SUBJECT: **LONGWOOD GARDENS - NURSERY GREENHOUSE**
PRELIMINARY LAND DEVELOPMENT PLAN DATED REVISED OCTOBER 22, 2018
ADDITIONAL CONSIDERATIONS PERTAINING TO HEADLIGHTS

**LONGWOOD GARDENS - NURSERY GREENHOUSE
PRELIMINARY LAND DEVELOPMENT PLAN DATED REVISED OCTOBER 22, 2018**

ADDITIONAL CONSIDERATIONS PERTAINING TO HEADLIGHTS

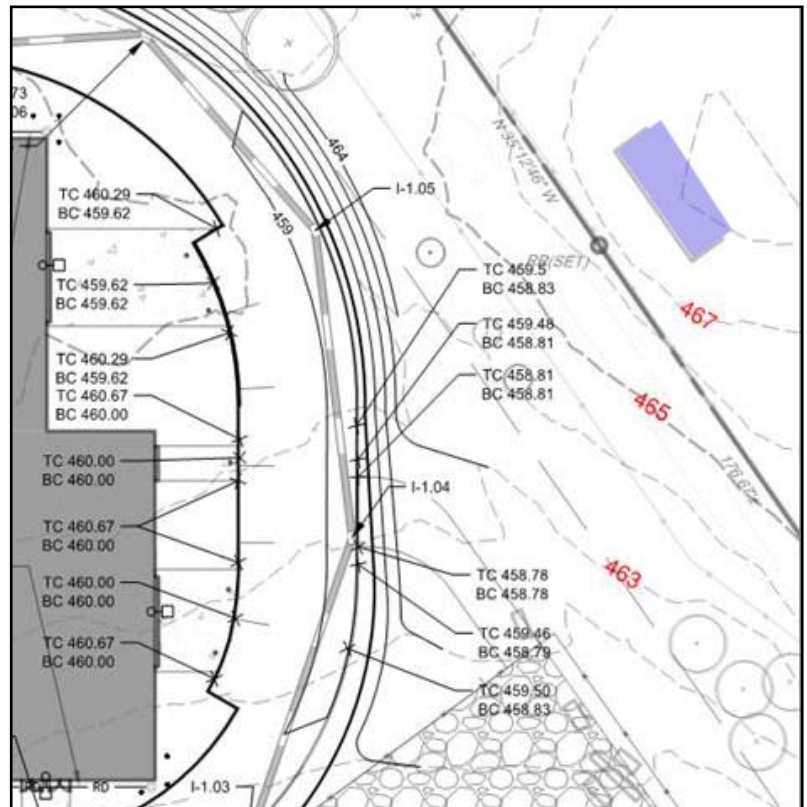
In addition to the contour elevations indicated along the proposed pavement, the excerpt to the right of the 10-22-2018 Plan is marked with additional contour elevations in red near the shared property line. (BC = "Bottom of Curb", referring to the elevations of the pavement.)

As can be seen in this Plan excerpt, there would be at least a seven foot (7') grade difference between the pavement around the proposed Greenhouse and the foundation of the Cifoletti dwelling (highlighted in blue), with the Greenhouse pavement being lower (around the 460' contour) than the "floor" elevation of the Cifoletti dwelling (around the 467' contour).

This elevation difference is greater than the height of any vehicle headlights that would likely be at the site, including high-clearance pickup trucks, tractor-trailers (the "cab"), agricultural tractors, and snow plow truck with high-mounted auxiliary headlights. *Therefore, this difference in elevation is, by itself and regardless of buffer plantings, sufficient to block direct glare from vehicle headlights.*
